Detailed Site Plan EcoGrads

DSP-21024

STAFF REPORT

SUBJECT: Detailed Site Plan DSP-21024
 EcoGrads

Figure 7: Wall signs located on the northwest and southwest corner of building

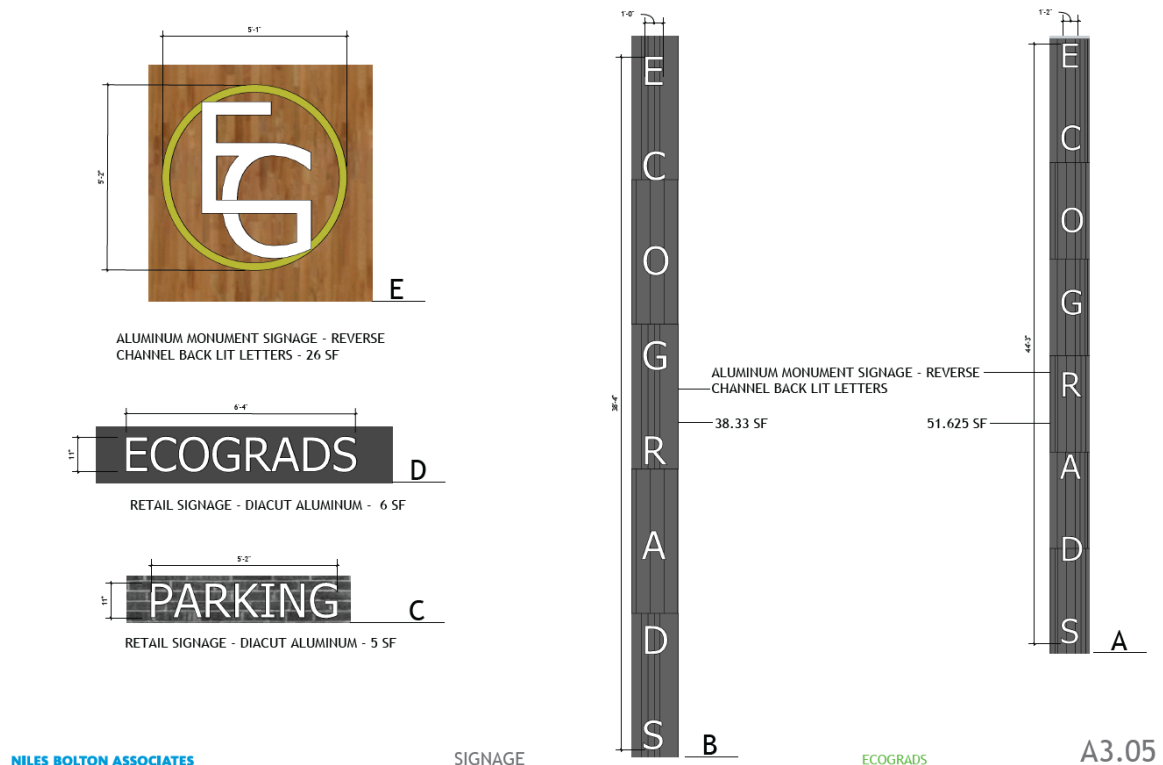
The applicant proposes multiple building-mounted signs on the building. Two back-lit, channel-letter, building-mounted signs will be located vertically on the northeast and southeast building façade that will be visible from US 1, as shown in Figure 8. Other building-mounted, back-lit, channel-letter signage is proposed along US 1 and Quebec Street, above the entrance to the residential and commercial lobbies. The submitted sign plan for the project includes square footage, but not all the details required to fully evaluate conformance with the sign requirements of the D-D-O Zone. A proposed condition has been included in the Recommendation section, requiring the applicant to provide scaled details of all the signs and elevation drawings showing their location on the façades, in accordance with the applicable sign requirements.

- e. Provide a sign table listing the number of signs, size, material, lighting, and their location on the façades, in accordance with the applicable Development District Overlay Zone standards.

Figure 9: Building Form exhibit from the Central US 1 Corridor Sector Plan

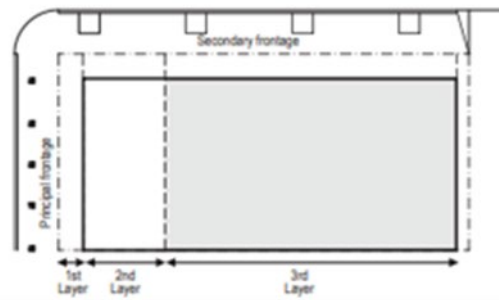
- a. **Page 234–Building Form/Setback:** In the Walkable Node, the principle front build-to-line shall be a maximum of 10 feet. The ground floor of the proposed building is set back 12.5 feet to provide for outdoor seating and dining. The remainder of the building on the upper stories varies from 3.5 feet to 21.5 feet.

The applicant states that the unique design of the building with the saw-tooth façade at Levels 2–7 has been designed to address the spirit of the build-to-line, and the setback at street level will provide space for safe and efficient outdoor seating along US 1 in front of the ground floor and allow for the ability to provide street amenities envisioned in the sector plan. The placement of the building provides area for landscaping with street trees and separation between the sidewalk and the travel lanes along US 1. Lastly, the applicant notes that the building placement is necessary to provide an increased build-to-line due to existing storm drains along the frontage of the property. Therefore, staff recommends **approval** of this amendment.
